Type 3 and Type 4 short circuit protection

May 2016
Yair Darshan

Objectives

Single-Signature PD Inherent 4-pairs protection -2

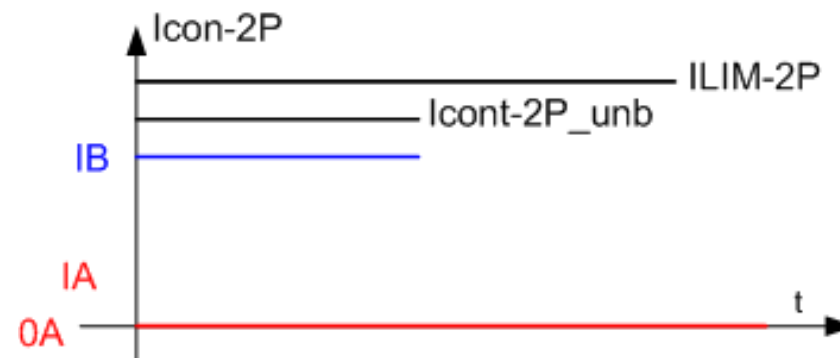
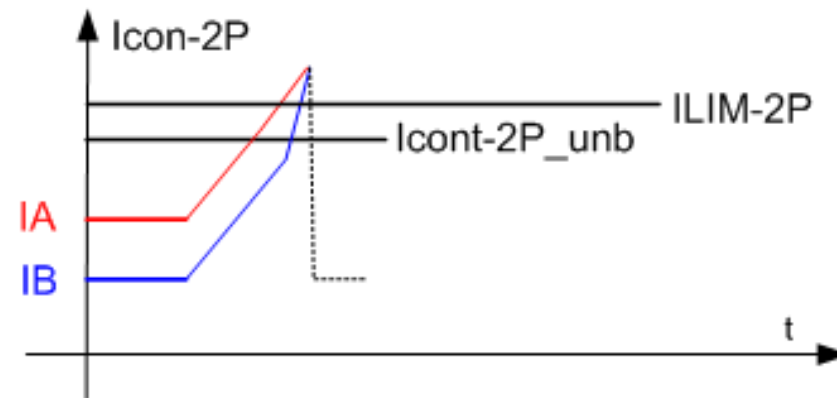
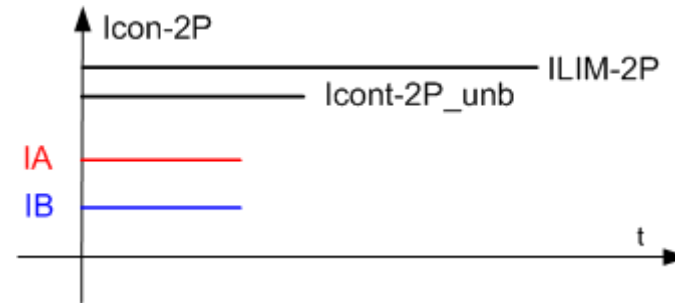
- The use case under discussion:
 - There is a short circuit on one of the pairs and power is removed from that pair.
if short still persists, the whole current will flow through the 2nd pair and that per will shut off too.
If short disappear due to the ability of the PD to work with lower power,

- Currents status before fault
- Currents status at fault of the 1st pair and 2nd pairset if PD can't work in reduced power mode after fault
- Currents status at fault of the 2nd pair if PD can work on 2-pairs after fault.

Annex A- Simulation results for Type 4 system at worst case conditions. Short load condition: pair A is in current limit and Pair B is not yet...

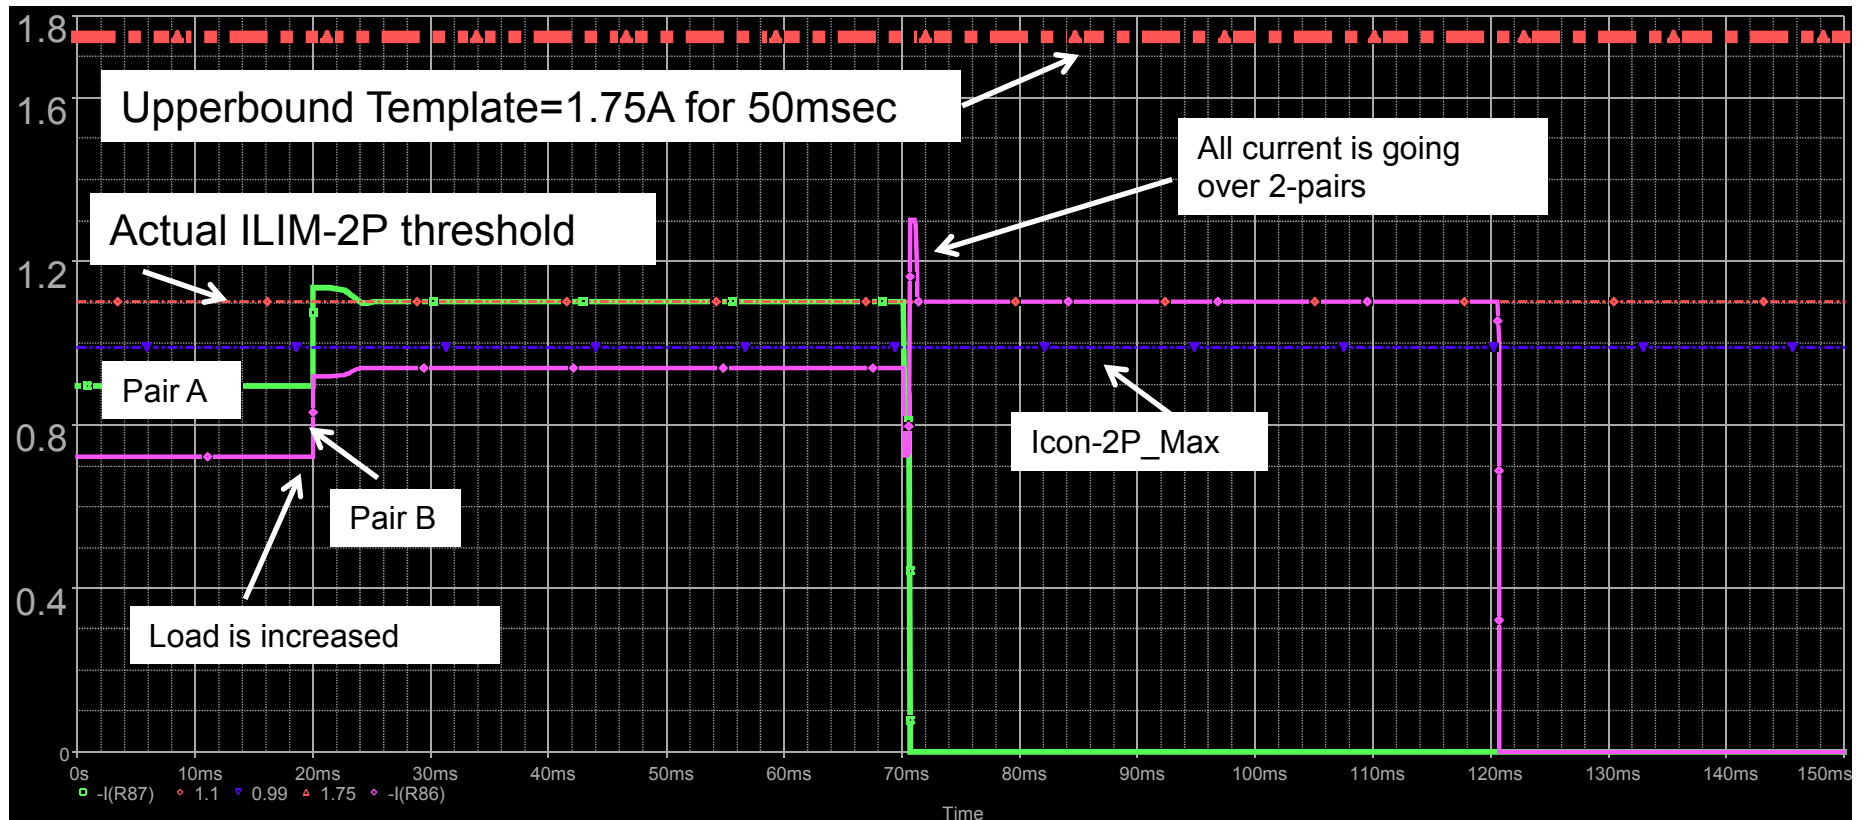
- Per pairset current limit is set to 1.1A. ($ILIM_MIN=0.99A$, $ILIM_2P_MAX<1.75A$ for 50msec max.)
- $I_{cont-2P_A}=0.89$, $I_{cont-2P_B}=0.72$. ($I_{con-2P_unb_MAX}=0.925A$)
- Under short load condition in which the pair with I_{con-2P_max} hits the current limit protection and the 2nd pair is not, we can see that after 50msec that pair is off and as a result all the current is going to the 2nd pair but its current limit is activated too and after 50msec this pair is power off too.

Annex B: Simulation results for Type 4 system at worst case conditions.

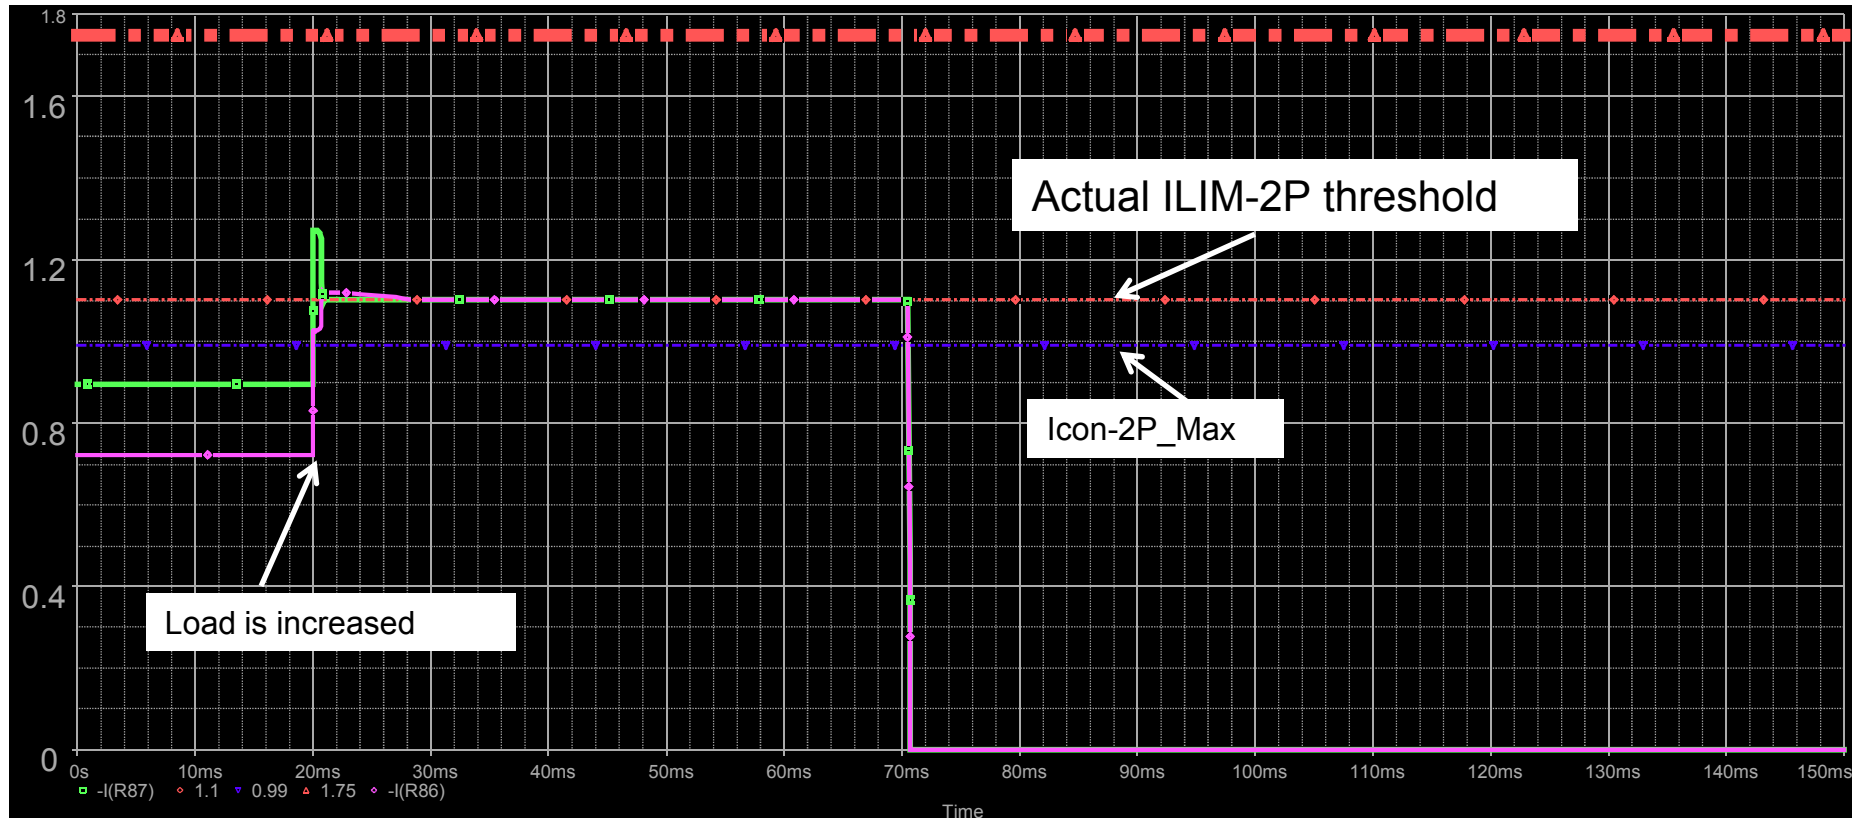
Short load condition: both pair A and pair B are in current limit.

- Per pairset current limit is set to 1.1A. (**ILIM_MIN=0.99A, ILIM_2P_MAX<1.75A for 50msec max.**)
- Icont-2P_A=0.89, Icont-2P_B=0.72. (**Icon-2P_unb_MAX=0.925A**)
- **Under short load condition in which BOTH pairs are in current limit, both of them automatically will power off after maximum 50msec.**

Annex C: Figure 33-29- Figure 33–29—POWER_ON state, per pairset operating current template for Type 4PSEs

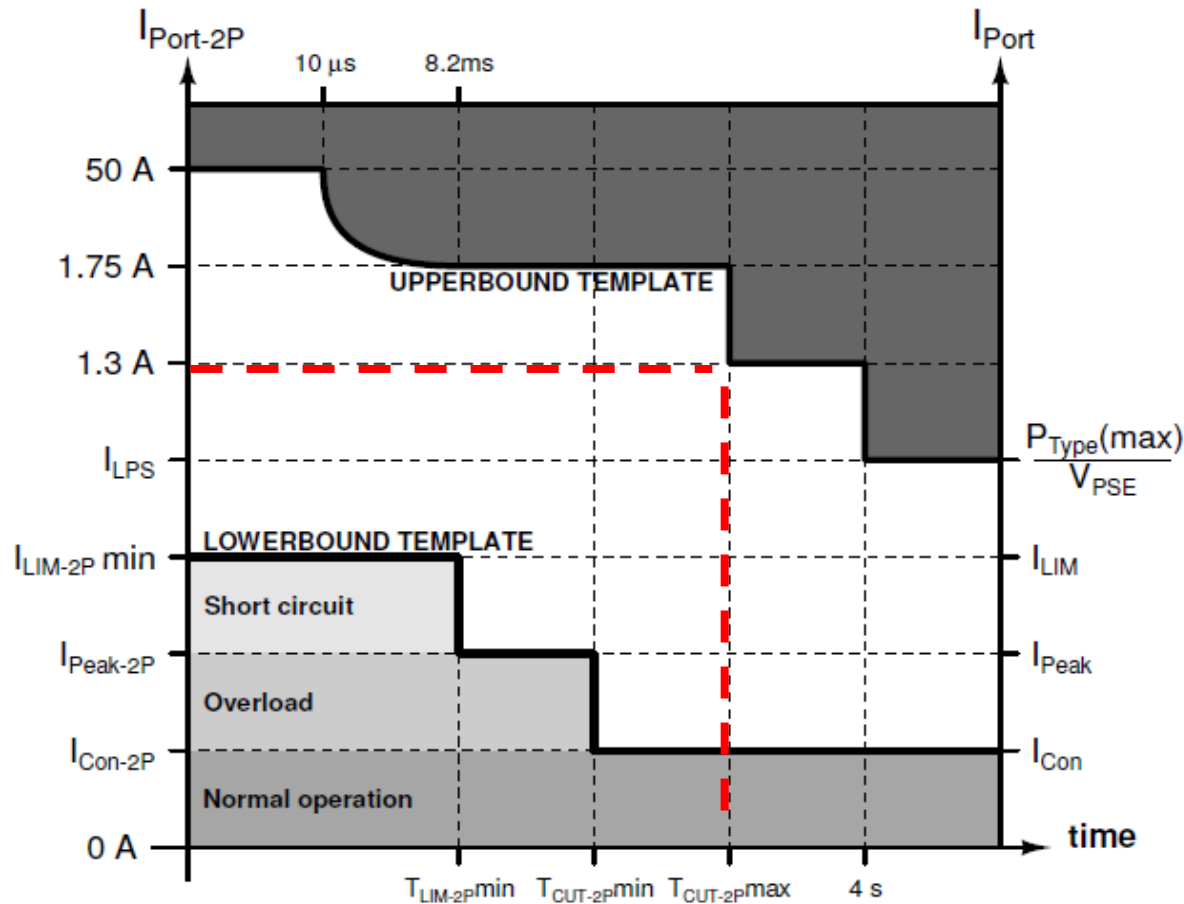
$(I_{LIM-2P} - \epsilon)$ per pairset can be anywhere between:

- 1.3A to 1.75A for T_{CUT-2P_MAX}
- I_{LPS} to 1.3A for 4sec
- I_{LIM-2P_MIN} to $(I_{LPS} - \epsilon)$ for ever
